Ford Bedliners & Wheel Well Liners

2021MY Model Change Overview

TAILGATE WORK SURFACE

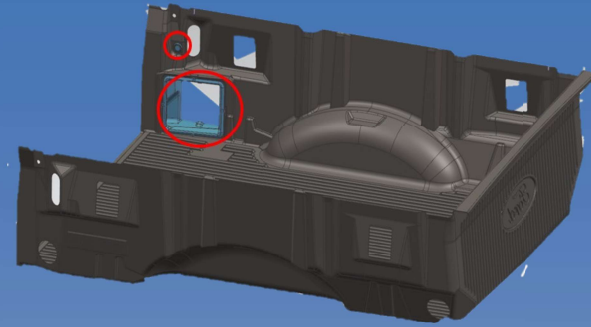
- The addition of 400w Onboard and Pro Power Onboard, hereinafter “PPO”, and Tailgate Work Surface (“TWS”) options necessitate changes to product and ordering.
 - PPO take rate estimate - ~70%
 - PPO on 5.5’ and 6.5’ only.
- Bedliners and Tailgates will now be ordered separately and have specific hardware kits.
- Bedliners and Tailgates will have new part numbers.

- 5.5’ & 6.5’ -
 - with PPO - **No.** The ambient light switch has moved and an opening created for PPO. A cover bezel and smaller 30mm light switch plug will be included in the hardware kit.

- without PPO - **No.** While the bedliner is similar to the P552, the tailgate and hardware has changed.
4. Are there different Bedliners for PPO and non-PPO trucks, or just different kits? **There are different bedliners for PPO and non-PPO trucks.** This requirement was necessitated by the move of the ambient light switch for PPO.
